FORM APPROVED OMB NO. 1004-0135 Expires: July 31, 2010 Lease Serial No. NMLC028784C If Indian, Allottee or Tribe Name 7. If Unit or CA/Agreement, Name and/or No. Well Name and No. **BURCH KEELY UNIT 375** API Well No. 30-015-33794 10. Field and Pool, or Exploratory GRAYBURG-JACKSON 11. County or Parish, and State EDDY COUNTY, NM ■ Water Shut-Off ☐ Well Integrity □ Other

Burch Keely Unit 375

# Permanent Abandonment of Federal Wells Conditions of Approval

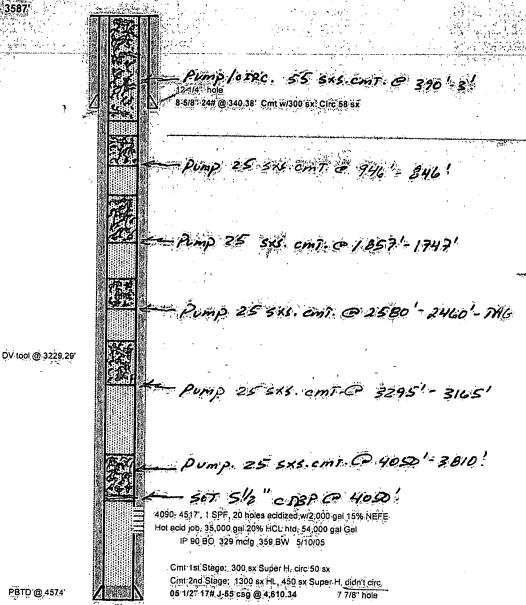
7) MIX X CHRC- TO SURF. 55 SXS.CMT. @ 390'-3'. Perfe 390-385 SQZ CMT to Surface,
8) DIG OUT X CUT OFF WELLHEAD 3' B.G.L.; WELD ON STEEL PLATE TO CSGS. X INSTALL GROUND LEVEL DRY,
HOLE MARKER. Verity ent to Suctace all annulus At cut-off DURING THIS PROCEDURE WE PLAN TO USE THE CLOSED-LOOP SYSTEM WITH A STEEL TANK AND HAUL CONTENTS TO THE REQUIRED DISPOSAL, PER OCD RULE 19.15.17. RECLAMATION PROCEDURE ATTACHED 14. I hereby certify that the foregoing is true and correct Electronic Submission #225543 verified by the BLM Well Information System For COG OPERATING LLC, sent to the Carlsbad Committed to AFMSS for processing by JOHNNY DICKERSON on 11/07/2013 () Name(Printed/Typed) DAVID A EYLER Title **AGENT** (Electronic Submission) Date 11/05/2013 Signature THIS SPACE FOR FEDERAL OR STATE OFFICE USE 11-13-1 Approved By Conditions of approval, if any, are attached. Approval of this notice does not warrant or certify that the applicant holds legal or equitable title to those rights in the subject lease which would enville the applicant to conduct operations thereon. Office
